SECTION 00942 - Change Order Form

No. 01DATE OF ISSUANCE: 07/29/2021EFFECTIVE DATE: 09/21/2021

OWNER: Indian River County
 CONTRACTOR Halley Engineering Contractors, Inc.
 Project: 66TH AVENUE ROADWAY WIDENING (49TH STREET TO 69TH STREET)
 OWNER's Project No. IRC-1505 OWNER'S Bid No. 2021018
 FM No.: 436379-1-54-01 & 436379-1-54-02

Incorporate Contractor's Proposal to re-design the foundations, substructure and superstructure of the proposed bridge – 66th Avenue Over North Relief Canal.

A PROPOSED BRIDGE ELEVATION
 Scale: 1" = 10'-0" (HORIZONTAL) 1" = 5'-0" (VERTICAL)

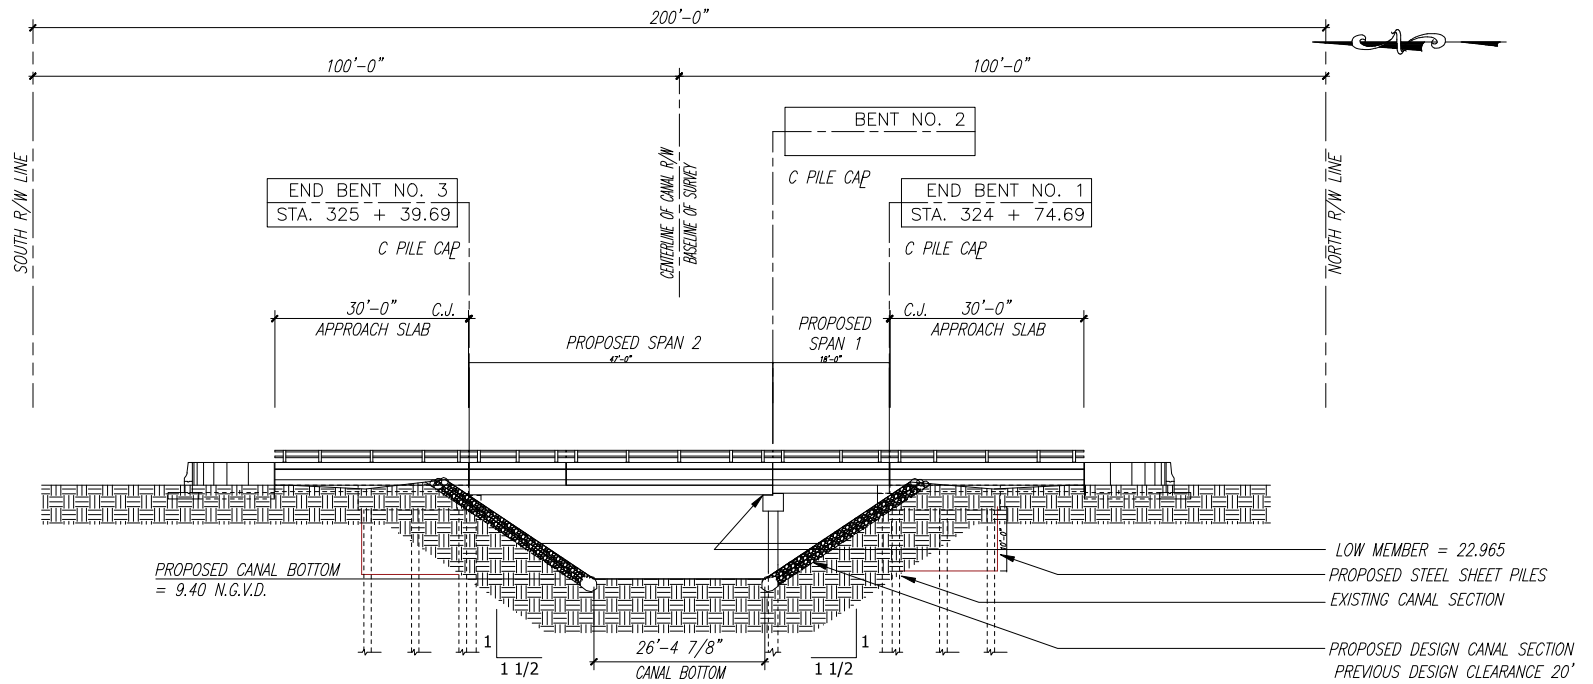
- IRC, HEC, FDOT agree that IRC will proceed with development of HEC's concepts, based upon the following:
 - Concept is based upon HEC's preliminary drawing dated 6/10/2021 (attached as Exhibit "A") and letter dated 6/3/2021 (attached as Exhibit "B").

- Reduction in the number of piling.
 - Reduction in the number of bridge bents.
 - Elimination of the transverse post-tensioning.
 - Design refinement may result in additional construction detail modifications without affecting the aesthetic view of the structure, provided the final design will meet the design criteria shown in the plans.

3. The bridge will only be 2 spans (15'-50') versus the present design of 3 spans (15'-35'-15'). This will eliminate one intermediate bent in the water. This will also reduce the chance debris clogging the canal by 50% due to the elimination of one intermediate bent. The drainage district would prefer no bents in the canal. On the 58th avenue bridge design we have a single span 53' bridge with beams and no bents in the canal.

4. We will change from the prestressed/post tension deck units with an asphalt topping to the prestressed Florida Slab Beam Design (FSB) with a 6" Reinforced Concrete topping

5. We will change the design of the concrete sheeting behind the end bents to a steel sheet pile wall that was proposed on 43rd Ave but was rejected for cost reasons.
